RE: **18-ZN-2022**
Magnolia on Osborn
6P130 (Key Code)

Planning & Development Services has completed review of the above referenced development application submitted on 1/27/2023. The following comments represent issues or deficiencies identified by the review team and are intended to provide you with guidance for compliance with city codes, policies, and guidelines.

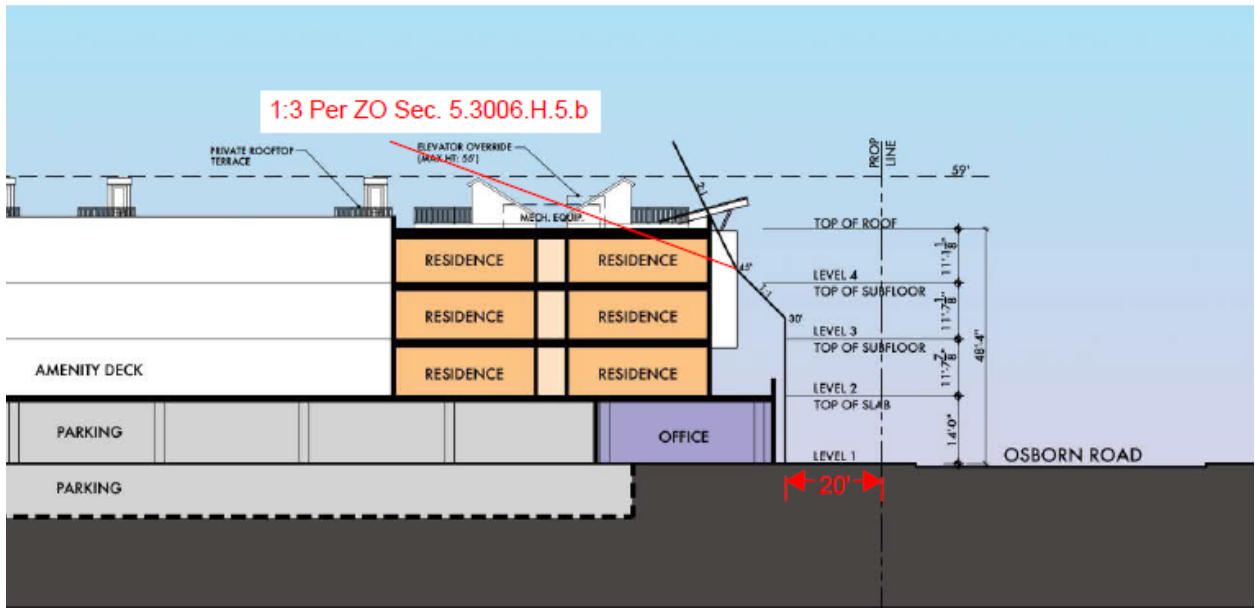
2. The General Plan 2035 (Policy CD 1.4) and the Old Town Scottsdale Character Area Plan (OTSCAP Goal CD 2) call for development that should sensitively transition in scale, height, and intensity at the Old Town boundary. The proposed development does not appear to comply with this requirement. With your next submittal, please revise the southern

stepbacks along the Old Town Boundary in accordance with Sec. 5.3006.H.5.b of the Zoning Ordinance. See the highlighted area below:
